Office Action Summary

10/732,942

DETAILED ACTION

FIG. 2

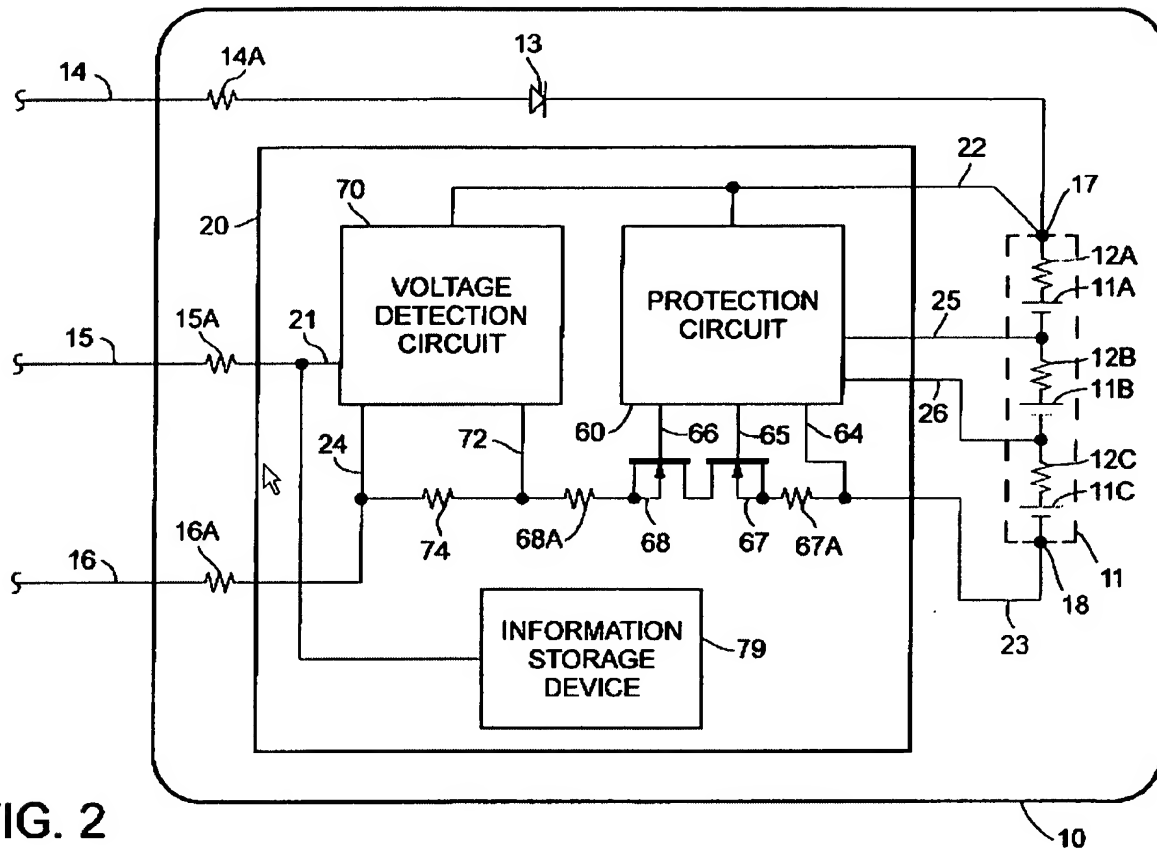
Ostergaard discloses in figures 1-13 controlling charging of a lithium ion battery based upon a measurement of charging current by measuring a voltage drop across a resistor R74 [see column 7, lines 43-45].

(19) Circuit 70 monitors the charging/discharging current by measuring the voltage drop across sense resistor 74 via lines 72 and 24. The protection

Ostergaard does not disclose an indicator responsive to said first charge indication signal for providing an indication when said lithium ion battery is at near full state-of-charge.

JP-08140281 discloses

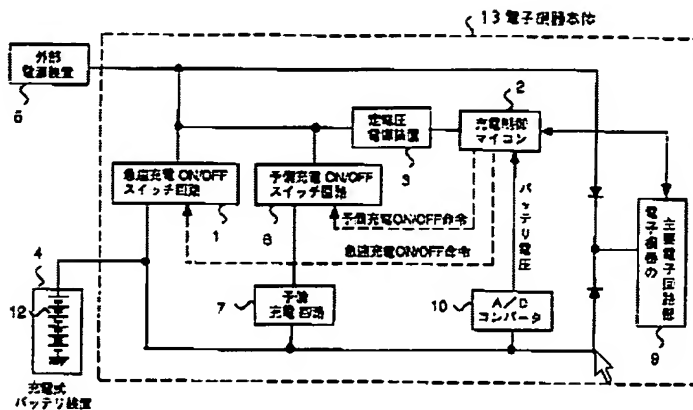
a charging control microcomputer 2 starts the charging, and turns off a quick charging ON/OFF switch circuit 1 so as to perform preliminary charging, and turns on a preliminary charging ON/OFF switch circuit 6. And, a charging control microcomputer 2 reads the output voltage of a charging battery device 4 through an AD converter 10, and if it is not less than the voltage with which the charging control microcomputer 2 can operate, the charging control microcomputer 2 turns off the preliminary charging ON/OFF switch circuit 6 and turns on the quick charging ON/OFF switch circuit 1 so as to perform quick charging until the output voltage of the chargeable battery device 4 becomes stable. Hereby, the chargeable battery device 4 overdischarged can be activated, and it can be quickly charged, with output increased.

JP-11164489 discloses

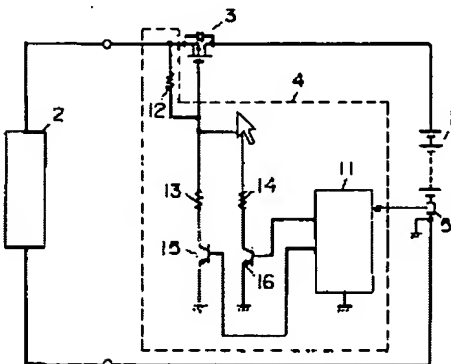
a charging controller is provided with a lithium battery 1, a charge power source 2 for charging the secondary battery 1, a charge switching FET 3 formed at a charging passage for charging the secondary battery 1 from the charge power source 2, and a charging control means 4 for controlling the charging switching FET 3. By controlling the voltage between the gate and source of the charging switching FET 3 through a charge control means 4 so that a charging current value becomes a prescribed value, quick charging and trickle current charging for the secondary battery 1 can be conducted with a single charging switching FET 3, and current control limiting resistance can be eliminated. Thus a charging controller built in secondary battery pack can be provided which is able to attain size reduction and trickle current charging at a low cost.
